Title:	Document #:	Date:
	Recall Notice - TS-0042 Trailer Winch Strap Routing	EWP. 374140.TKR.TOPPER-TRAILER.600	4/9/2025

Recall #TS-0042 : Trailer Winch Strap Routing

Tracker Topper™ Trailer 374140 KIT, TRAILER ROLLER INSTALL

Without Roller Installed

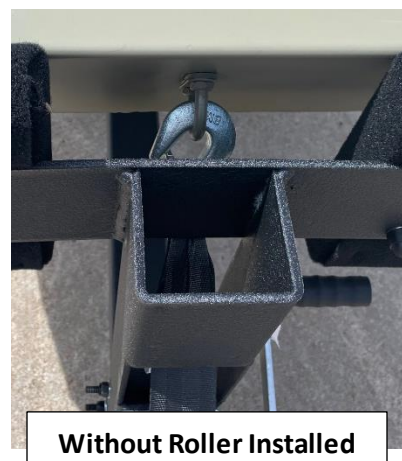
Purpose: This document is intended to guide dealers on the essential modifications needed to install a 3-inch roller into the existing winch stand. The current winch stand configuration may lead to potential fraying of the strap as it comes into contact with the metal crossbar of the forward bunk assembly. This contact could result in fraying of the winch strap when it is pulled tight.

Current State: Assess the current condition of the winch stand to confirm that it has not undergone any modifications, such as the addition of a 3-inch strap roller. During this assessment, it is crucial to inspect the condition of the existing winch strap. Verify that there are no signs of fraying or damage to the strap. If any damage is detected, kindly request a replacement.

Alterations: Installation of a 3-inch roller allows the strap to be deflected from touching the metal. This requires dealers to drill two 7/16" holes in the winch stand, installing a bolt, washers, nut and roller.
